Form 3160-5 (June 2019)

1. Type of Well Oil Well Gas	Well Other		8. Well Name and No	O. STREETCAR 15 FED 405H		
2. Name of Operator EOG RESOUR	CES INCORPORATED		9. API Well No. 30-0	125-47512		
	BBY 2, HOUSTON, TX 770 3b. Phone No. (713) 651-70		10. Field and Pool or DRAPER MILL; B	Exploratory Area

Update casing and cement program to current design.

Revised Permit Information 10/04/2023:

190' FSL
 Revised Wellbore A:
 KB: 3390'

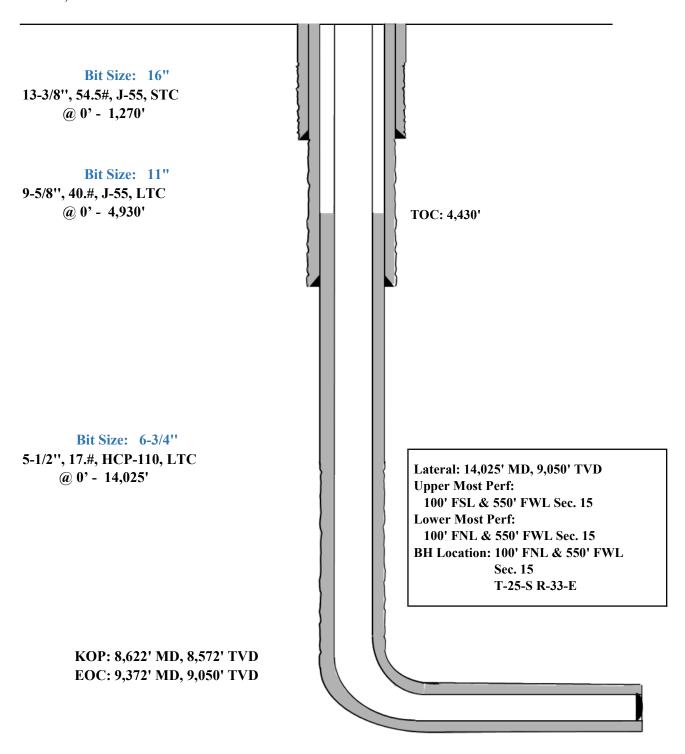
Casing Program A:

Hole	Interv	al MD	Interva	al TVD	Csg			
Size	From (ft)	To (ft)	From (ft)	To (ft)	OD	Weight	Grade	Conn
16"	0	1,270	0	1,270	13-3/8"	54.5#	J-55	STC
11"	0	4,982	0	4,930	9-5/8"	40#	J-55	LTC
6-3/4"	0	14,025	0	9,050	5-1/2"	17#	HCP-110	LTC

Variance is requested to waive the centralizer requirements for the 9-5/8" casing in the 11" hole size. An expansion additive will be utilized, in the cement slurry, for the entire length of the 11" hole interval to maximize cement bond and zonal isolation.

Variance is also requested to waive any centralizer requirements for the 5-1/2" casing in the 6-3/4" hole size. An expansion additive will be utilized, in the cement slurry, for the entire length of the 6-3/4" hole interval to maximize cement bond and zonal isolation.

EOG requests permission to allow deviation from the 0.422" annulus clearance requirement for the intermediate (salt) section from Onshore Order #2 under the following conditions:

190' Revised Wellbore B: KB: 3390' GL: 3365'

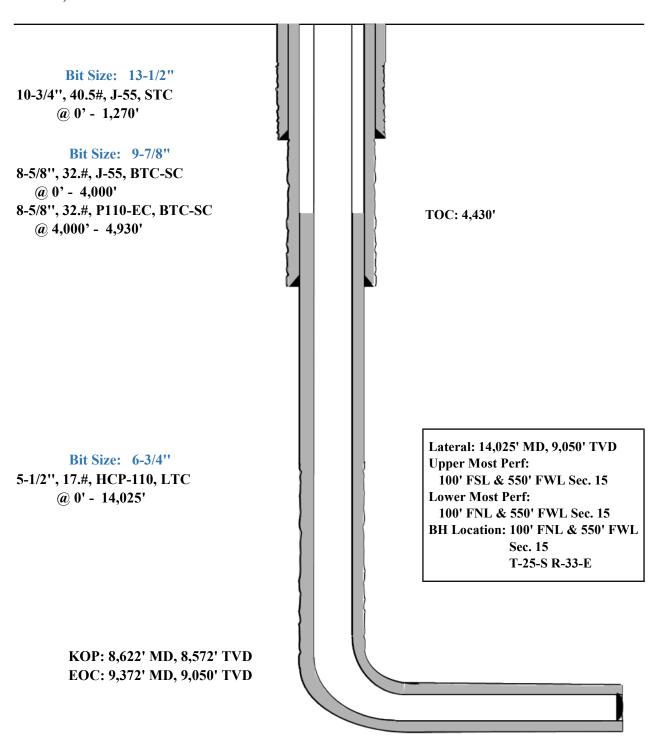
Casing Program B:

Hole	Interv	al MD	Interva	al TVD	Csg			
Size	From (ft)	To (ft)	From (ft)	To (ft)	OD	Weight	Grade	Conn
13-1/2"	0	1,270	0	1,270	10-3/4"	40.5#	J-55	STC
9-7/8"	0	4,051	0	4,000	8-5/8"	32#	J-55	BTC-SC
9-7/8"	4,051	4,981	4,000	4,930	8-5/8"	32#	P110-EC	BTC-SC
6-3/4"	0	14,025	0	9,050	5-1/2"	17#	HCP-110	LTC

Variance is requested to waive the centralizer requirements for the 8-5/8" casing in the 9-7/8" hole size. An expansion additive will be utilized, in the cement slurry, for the entire length of the 9-7/8" hole interval to maximize cement bond and zonal isolation.

Variance is also requested to waive any centralizer requirements for the 5-1/2" casing in the 6-3/4" hole size. An expansion additive will be utilized, in the cement slurry, for the entire length of the 6-3/4" hole interval to maximize cement bond and zonal isolation.

EOG requests permission to allow deviation from the 0.422" annulus clearance requirement for the intermediate (salt) section from Onshore Order #2 under the following conditions:

Design A

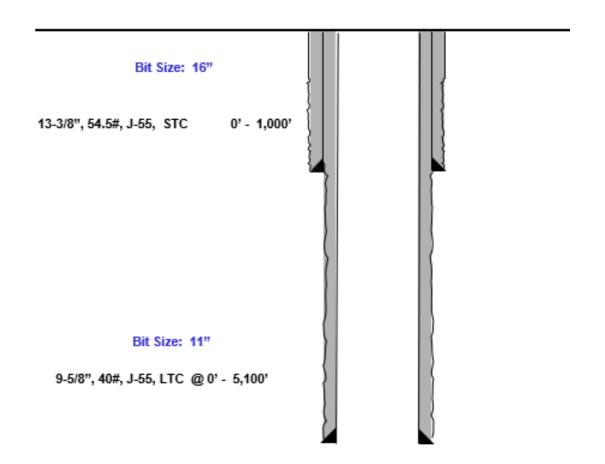
Proposed 11" Hole with 9.625" 40# J55/HCK55 LTC Casing

- 11" Bit + 0.52" Average hole enlargement = 11.52" Hole Size
 - 0.9475" Clearance to casing OD

• 0.4475" Clearance to coupling OD

- Previous Shoe 13.375" 54.5# J55 STC
 - 0.995" Clearance to coupling OD (~1,200' overlap)

Design B

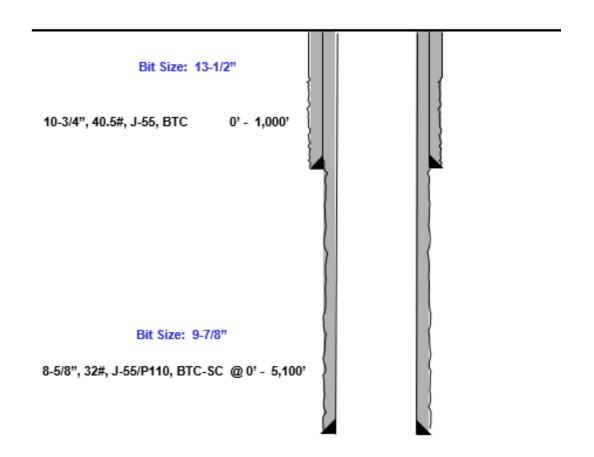
Proposed 9.875" Hole with 8.625" 32# J55/P110 BTC-SC Casing

- 9.875" Bit + 0.42" Average hole enlargement = 10.295" Hole Size
 - 0.835" Clearance to casing OD

• 0.585" Clearance to coupling OD

- Previous Shoe 10.75" 40.5# J55 STC
 - 0.4625" Clearance to coupling OD (~1,200' overlap)
